## AP1000DCDFileNPEm Resource

## AP1000 TECHNICAL REPORT REVIEW

RAI Response Number: RAI-TR44-002

1. APP-GW-GLR-026, Revision 0, "New Fuel Storage Rack Structural/Seismic Analysis," (Technical Report Number 44)
2. APP-FS02-Z0C-001, Revision 0, "Analysis of AP1000 Fuel Storage Racks Subjected to Fuel Drop Accidents"

Figure 44-2.1 Stress Strain Curve for SA240-304 Stainless Steel

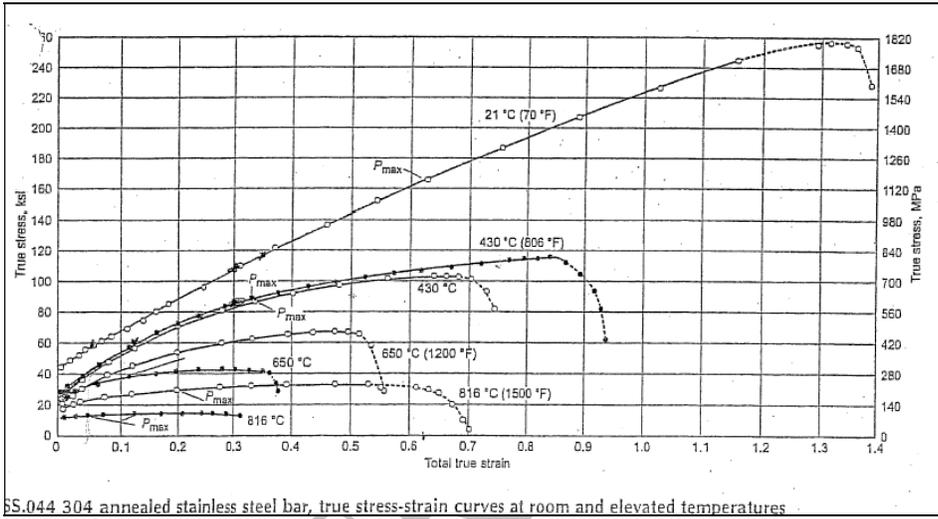
Section 2.8.5 states that appropriate non-linear material properties have been applied to the rack components to permit yielding and permanent deformation. Table 2-6 only provides Young's modulus, yield strength, and ultimate strength, which are not sufficient to define an engineering stress-strain curve. In addition, LYDYNA requires true stress-strain relation for its nonlinear materials. Therefore, provide the following: (1) a complete description of the material stress-strain curve and confirm that a true stress-strain curve was used in these impact analyses and (2) a description of the fuel assembly model, including the element properties and material properties for the dropped fuel assembly.

This RAI is superseded in its entirety by the drop accident methodology presented in RAI-TR44-01 R1 and RAI-TR44-06 R2, both dated 8/13/10. These responses clarify the new fuel assembly drop accidents onto the new fuel racks are not considered to be applicable for the AP1000 design since this event is considered unlikely based on the single-failure-proof hoist operations discussed in these responses.

1) The new fuel racks are fabricated from SA240-304 and SA564-630 stainless steel. For the impact analyses, a true-stress strain curve, which is obtained from Atlas of Stress Strain Curves (2nd Edition, ASM International) and reproduced below as Figure TR44-2.1, is used to define the strength properties of SA240-304 stainless steel.

#### Figure TR44-05.1 Fuel Assembly Deep Drop Scenario 1 for New Fuel Rack

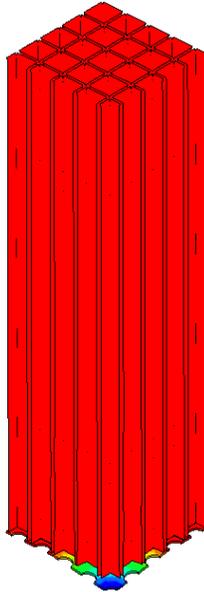
Section 2.8.5 does not indicate whether other fuel assemblies are in place, when a fuel assembly drops through an empty cell and impacts the baseplate at its center. Depending on how the baseplate is designed, a full load of fuel assemblies may introduce progressive deformation after a fuel assembly impacts at the center of the baseplate. The maximum downward deformation of the baseplate is about 3.8 inches, as shown in Figure 2-10. This may be significant enough to initiate a progressive deformation. Therefore, provide: (1) the assumption on the existing fuel assemblies when the impact occurs, (2) the design basis for the baseplate, and (3) a figure similar to Figure 2-10, that shows the cells together with the severely deformed baseplate.

**This RAI is superseded in its entirety by the drop accident methodology presented in RAI-TR44-01 R2 and RAI-TR44-06 R3, both dated 8/13/10. These responses clarify the new fuel assembly drop accidents onto the new fuel racks are not considered to be applicable for the AP1000 design since this event is considered unlikely based on the single-failure-proof hoist operations discussed in these responses.**

- 3) Figure TR44-005.1 below shows the cells together with the severely deformed baseplate for the same LS-DYNA solution as shown in Figure 2-10. Note that the deformation of the cells is not significant compared to the baseplate. This is because the cell-to-baseplate weld connections break as a result of the postulated fuel impact load before the cell walls are permanently deformed.

Figure 2-9 Results from Drop on AP1000 New Fuel Storage Rack

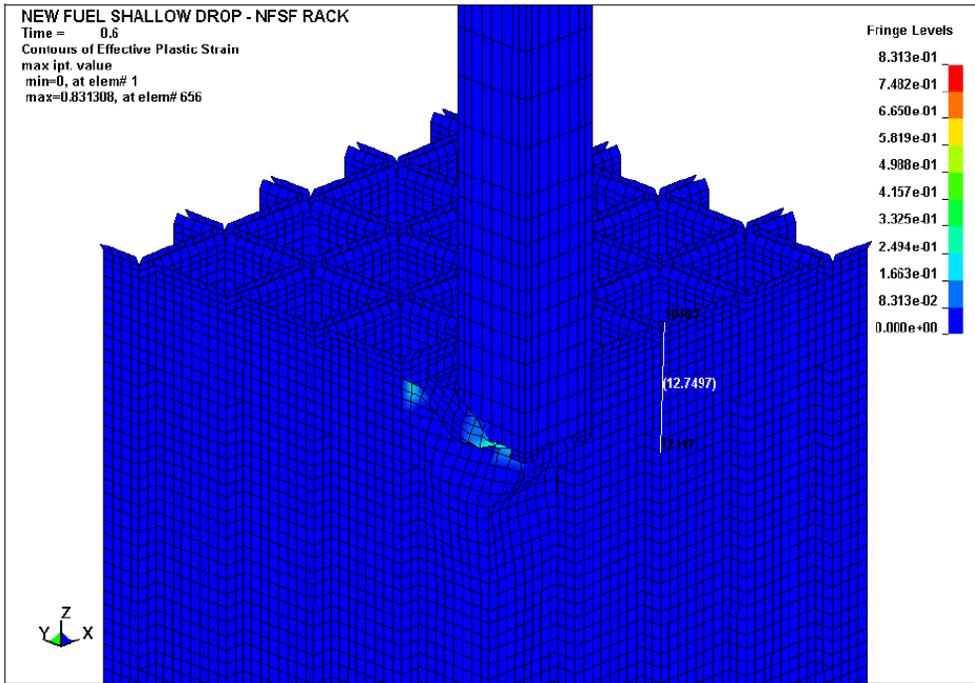
Figure 2-9 of this report shows the permanent deformation at the top of a cell wall. The permanent deformation is measured as 10.26 inches, which is smaller than the limit of 14 inches. However, the figure also shows indications of nontrivial hourglassing, which may significantly affect the accuracy of the analysis result. The mesh at the impact location should be locally refined, to ensure convergence with mesh size. Therefore, an additional analysis with a finer mesh at the impact region should be performed to confirm that the model is suitable.

The general acceptance criterion for the 36 inch fuel assembly drop onto the top of a new fuel storage rack is to maintain the stored fuel assemblies in a subcritical configuration. In measurable terms, the permanent deformation of the rack (measured downward from the top of rack) is limited to 15.27 inches, which is the distance from the top of the rack to the top of the neutron absorber panel. This limit is conservative because the active fuel region begins two inches below the top of the neutron absorber panels. Therefore, more margin exists than Technical Report APP-GW-GLR-026 indicates, and a mesh convergence study is not required.

The 36" fuel assembly drop onto the top of the new fuel rack was re-analyzed in Revision 1 of APP-FS02-Z0C-001, "Analysis of AP1000 Fuel Storage Racks Subjected to Fuel Drop Accidents", with consideration of strain rate effects for the welds. The new analysis shows that the maximum permanent deformation of the rack cell wall is 12.75" (measured from the top of rack) versus the allowable limit of 20.83". This allowable limit is the distance from the top of the rack to the top of the poison panel, which is 2 inches above the top of the active fuel. Note the height of the new fuel rack cell was increased by 6 inches. Since the active fuel region is surrounded by an undamaged cell wall, there is no longer a need to demonstrate that the refinement of the model is adequate in the localized region of the impact zone.

Figure 2-9 was replaced with the following figure:
